OCTOBER 1978

The Commission has issued the enclosed Amendments Nos. 65, 65 and 62 for Licenses Nos. DPR-33, DPR-47 and DPR-55 for the Oconee Nuclear Station, Units Nos. 1, 2 and 3. These amendments consist of changes to the Station's common Technical Specifications and are in response to your requests dated April 20, 1978 and June 26, 1978, as supplemented April 27, August 21 and 28, September 6, 22 and 26, 1978.

These amendments revise the Technical Specifications to support the operation of Oconee Unit No. 1 at full rated power during Cycle 5 after core reload, removal of the orifice rod assemblies from the core, and High Pressure Injection Pump operability and operating procedure requirements in the unlikely event of a small break loss-of-coolant accident. By letter dated October 19, 1978, you reported that two steam generator tube plugs were unaccounted for and should be assumed to be in the primary coolant system. Your letter included a safety analysis of this concern. We reviewed your submittal and Appendix A to our enclosed Safety Evaluation represents our evaluation of the safety consequences of these two plugs.

ATTACHMENTS TO LICENSE AMENDMENT

CORE PROTECTION
SAFETY LIMITS
UNIT 1

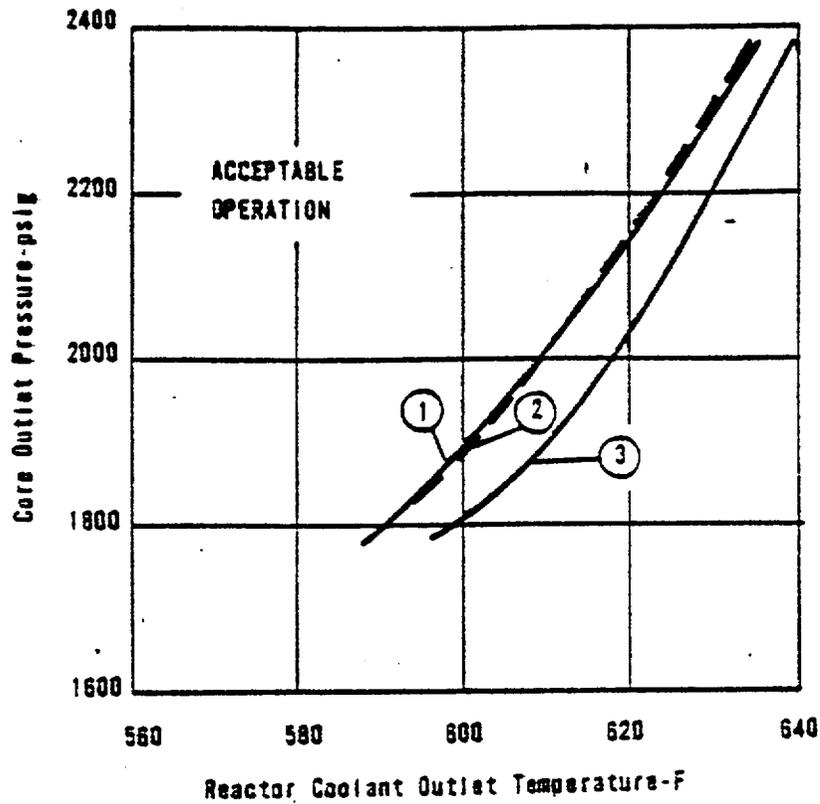
The specified flow rates for Curves 1, 2, and 3 of Figure 2.1-2A correspond to the expected minimum flow rates with four pumps, three pumps, and one pump in each loop, respectively.

CURVE	RC FLOW (GPM)
1	374,880
2	280,035
3	183,690

CURVE	REACTOR COOLANT FLOW (GPM)	POWER	PUMPS OPERATING	TYPE OF LIMIT
1	374880 (100%)*	112%	4	(DNBR)
2	280035 (74.7%)	85.3%	3	(DNBR)
3	183690 (49.0%)	58.2%	2	(QUALITY)

Figure 2.1-3A

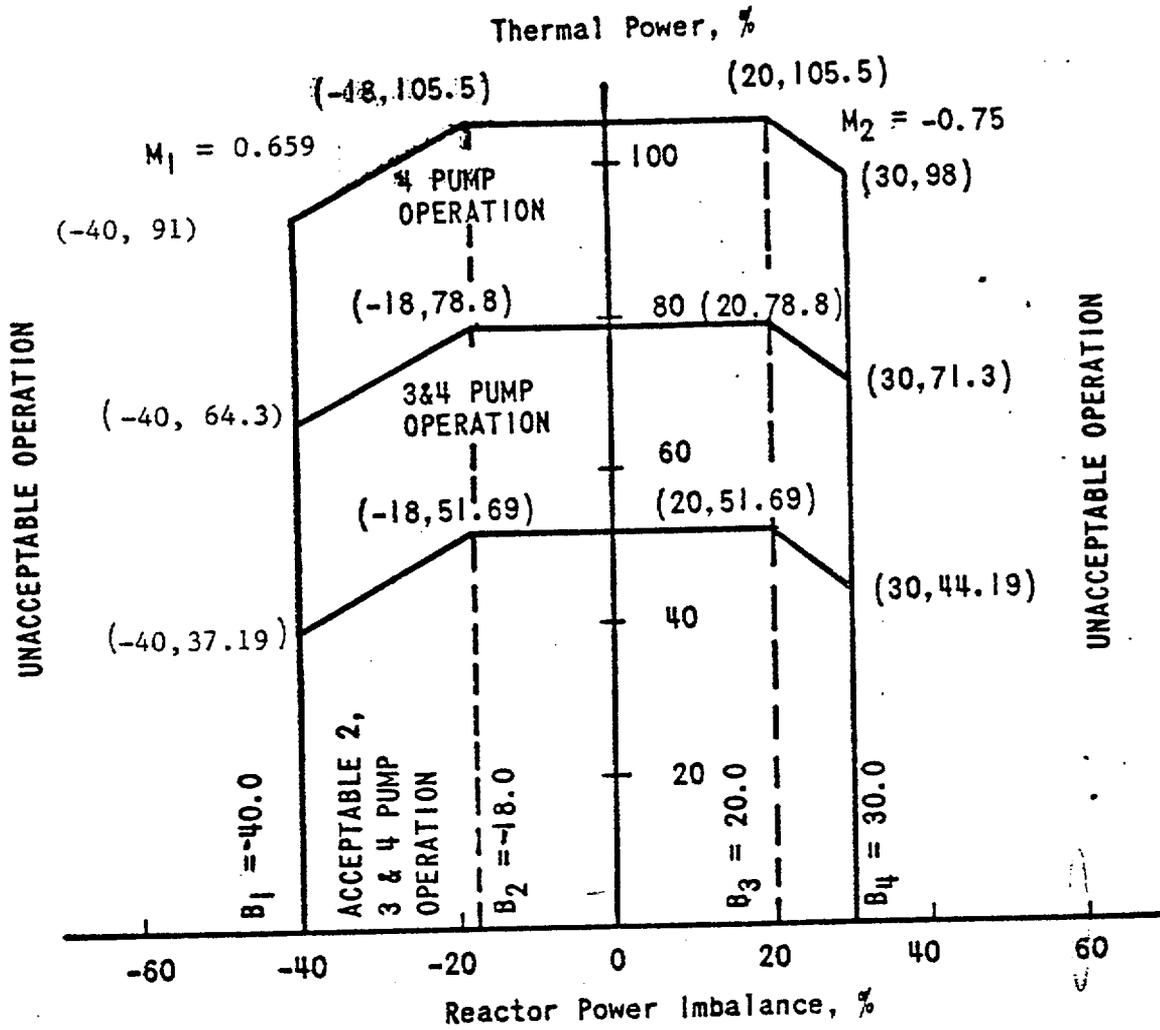
The curve of Figure 2.1-1A is the most restrictive of all possible reactor coolant pump-maximum thermal power combinations shown in Figure 2.1-3A.

The maximum thermal power for three-pump operation is 85.3 percent due to a power level trip produced by the flux-flow ratio 74.7 percent flow \times 1.055 = 78.8 percent power plus the maximum calibration and instrument error. The maximum thermal power for other coolant pump conditions are produced in a similar manner.

Figure 3.5.2-1A1

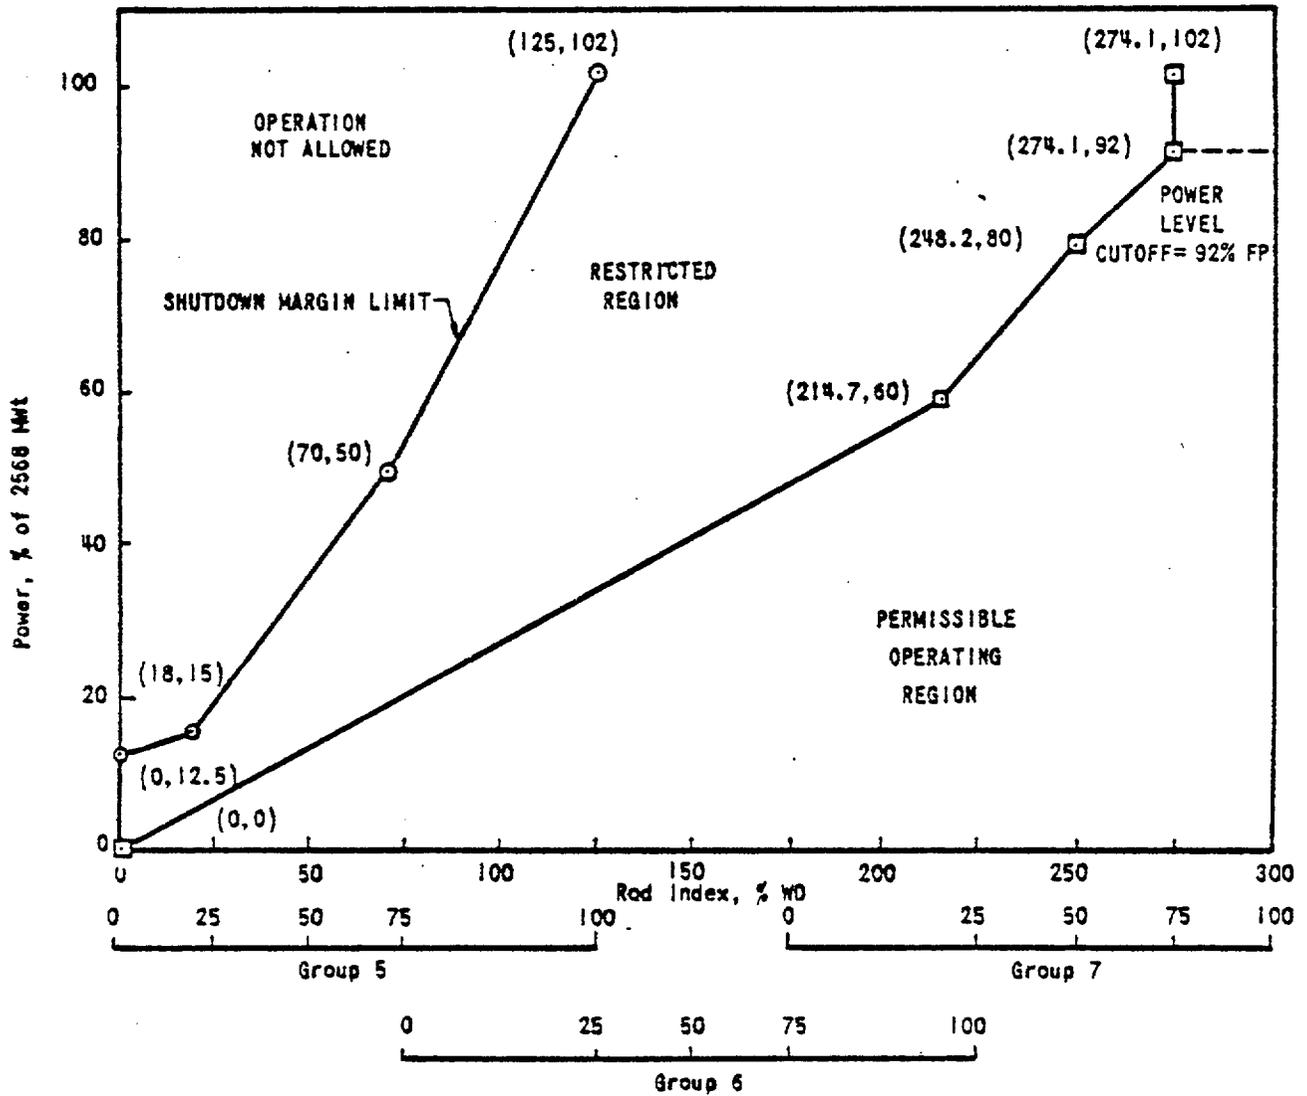
- a. Except for physics tests, reactor power in Unit 1 shall not be increased above the power-level-cutoff shown in Figures 3.5.2-1A1, and 3.5.2-1A2 unless one of the following conditions is satisfied:

Figure 3.5.2-2A2

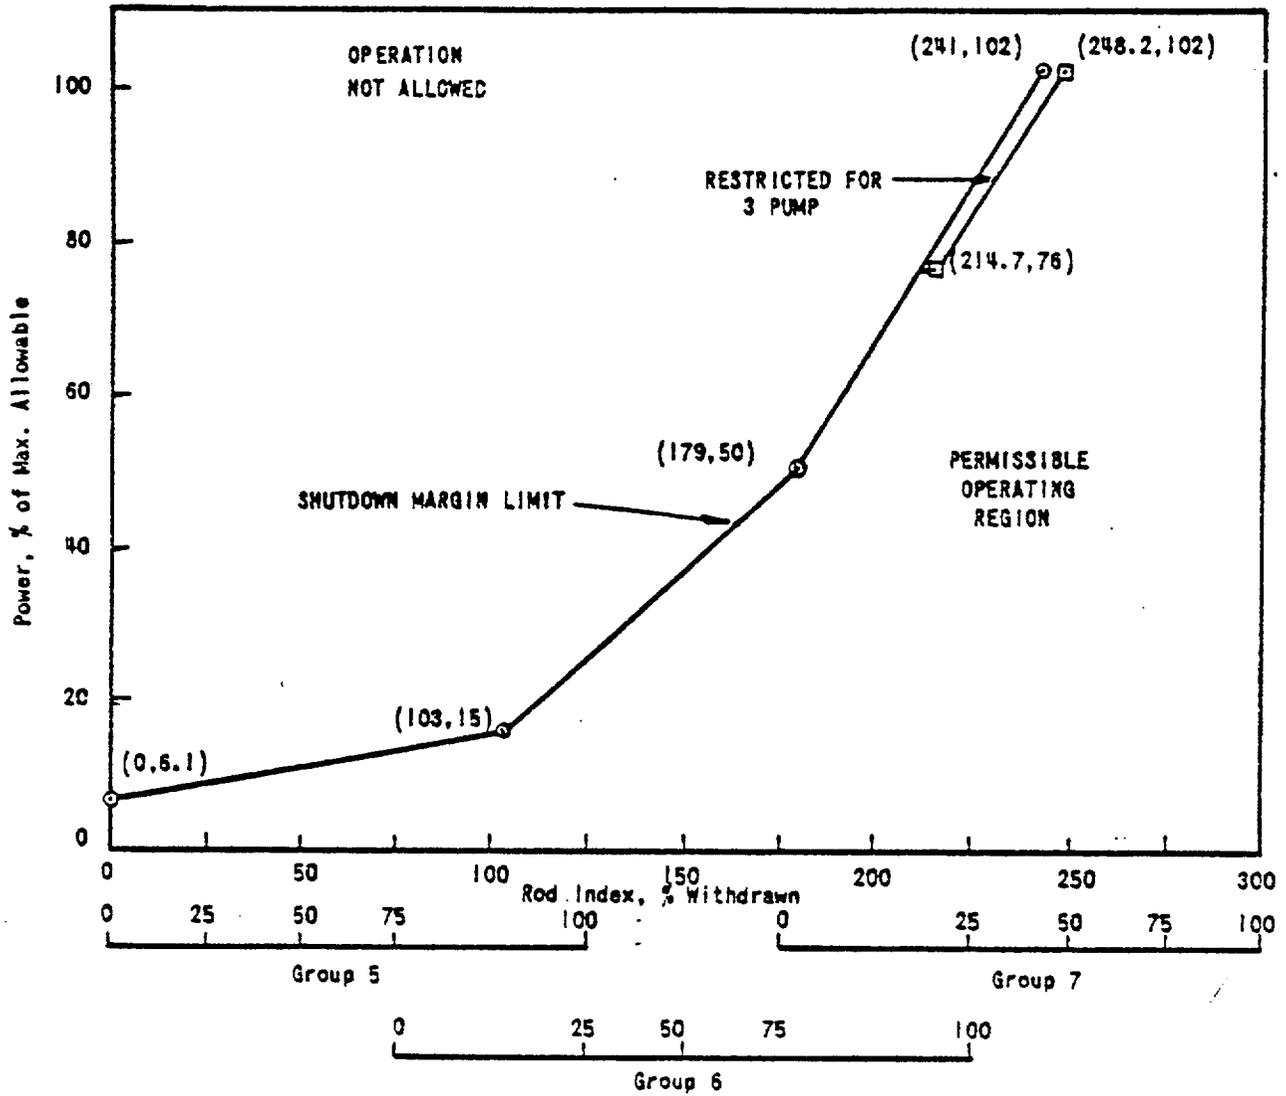
The power-imbalance envelope defined in Figures 3.5.2-3A1, 3.5.2-3A2, 3.5.2-3B1, 3.5.2-3B2, 3.5.2-3B3, 3.5.2-3C1, 3.5.2-3C2 and 3.5.2-3C3 is based on LOCA analyses which have defined the maximum linear heat rate (see Figure 3.5.2-5) such that the maximum clad temperature will not exceed the Final Acceptance Criteria. Corrective measures will be taken immediately should the indicated quadrant tilt, rod position, or imbalance be outside their specified boundary. Operation in a situation that would cause the Final Acceptance Criteria to be approached should a LOCA occur is highly improbable because all of the power distribution parameters (quadrant tilt, rod position, and imbalance) must be at their limits while simultaneously all other engineering and uncertainty factors are also at their limits.** Conservatism is introduced by application of:
